SBN-368
T.F. B7.1.2

Subject: Revised Responses to 430 Series RAIs; (Power Systems Branch)

RAI 430.99 (9.5.5)

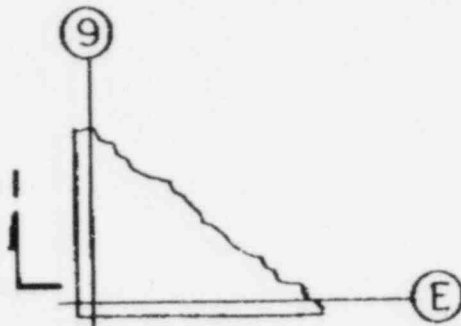
In Section 9.5.5 of the PSAR you state that the diesel generator component cooling water heat exchanger is not located in the diesel generator building but in the primary auxiliary building, Figure 9.5-6 confirms this arrangement and it also shows that the diesel generator cooling water lines are routed from the diesel generator building through the plant yard before entering the primary auxiliary building. No mention is made about the exact routing of the piping or tornado missile protection for these lines. Provide the following:

- a. Indicate where these lines are located (above or below ground) and the tornado missile protection provided for these lines. If none is provided, it is our position that tornado missile protection be provided. Comply with this position.

- b. Provide a discussion of the external corrosion protection provided for this piping. Where corrosion protective coatings are being considered, include the industry standards which will be used in their application. If this piping is buried, discuss what provisions will be made in the design of this piping in the use of an impressed current type cathodic protection system in addition to waterproof protective coatings to minimize corrosion of buried piping. If cathodic protection is not being considered, provide your justification supplements by adequate drawings.

- c. It is our position that if the cooling water piping for diesel generator room 1A passes through diesel generator room 1B or if the piping for both diesel generators are in close proximity to each other such that a single accident, such as a tornado missile or high energy line pipe break, could damage both the trains, then this is unacceptable and your design will have to be revised. Provide a description supplemented by adequate drawings of the routing of the cooling water piping for both trains. Include in the description sufficient information to show that the piping is adequately separated or protected and that any single accident will not degrade both trains.

- a. The D-G cooling water lines exit the D-G building below grade through the west wall and enter the PAB below grade. Both buildings are seismic Category I and provide tornado missile protection for equipment and piping inside the buildings. The underground portions of the cooling water lines are a minimum of seven feet below grade, to provide protection against freezing and tornado missiles.
- b. The buried piping has been coated and wrapped prior to installation with Tapecoat-20, applied in accordance with the manufacturer's recommendations and standard industry practice. An impressed current system for cathodic protection has been provided.
